SAHUARITA ORDINANCE NO. 2026-197

AN ORDINANCE OF THE COUNCIL OF THE TOWN OF SAHUARITA, ARIZONA, AMENDING TITLE 15 BUILDINGS AND CONSTRUCTION, CHAPTER 15.05 BUILDING CODES, REPEALING SECTION 15.05.020 BUILDING CODE ADOPTED IN ITS ENTIRETY AND ADOPTING A NEW SECTION 15.05.020 BUILDING CODE ADOPTED BY DECLARING THE “TOWN OF SAHUARITA INTERNATIONAL BUILDING CODES, JULY 1, 2026” A PUBLIC RECORD; ADOPTING THE “TOWN OF SAHUARITA INTERNATIONAL BUILDING CODES, JULY 1, 2026” BY REFERENCE; ALL RELATED TO THE ADOPTION OF UPDATED INTERNATIONAL BUILDING CODES INCLUDING: (1) 2024 INTERNATIONAL BUILDING CODE, AS AMENDED; (2) 2024 INTERNATIONAL RESIDENTIAL CODE, AS AMENDED; (3) 2024 INTERNATIONAL PROPERTY MAINTENANCE CODE, AS AMENDED; (4) 2024 INTERNATIONAL PLUMBING CODE, AS AMENDED; (5) 2024 INTERNATIONAL FUEL GAS CODE, AS AMENDED; (6) 2024 INTERNATIONAL MECHANICAL CODE, AS AMENDED; (7) 2023 NATIONAL ELECTRICAL CODE, AS AMENDED; (8) 2018 INTERNATIONAL ENERGY CONSERVATION CODE, AS AMENDED; (9) 2024 INTERNATIONAL FIRE CODE, AS AMENDED; (10) 2012 SAHUARITA OUTDOOR LIGHTING CODE, DATED JANUARY 14, 2013; (11) 2024 INTERNATIONAL SWIMMING POOL AND SPA CODE, AS AMENDED; AND (12) 2024 INTERNATIONAL EXISTI

Figure D103.1 Dead-end fire apparatus access road turnaround. Revise as follows:

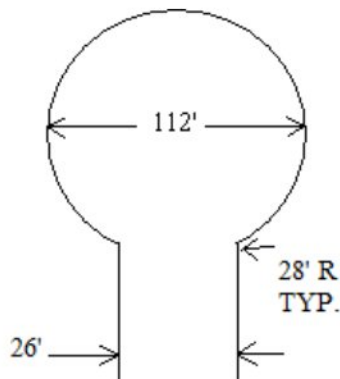
Add the following:

“112-FOOT DIAMETER
CUL-DE-SAC”
Measured from Asphalt to
Asphalt edges.
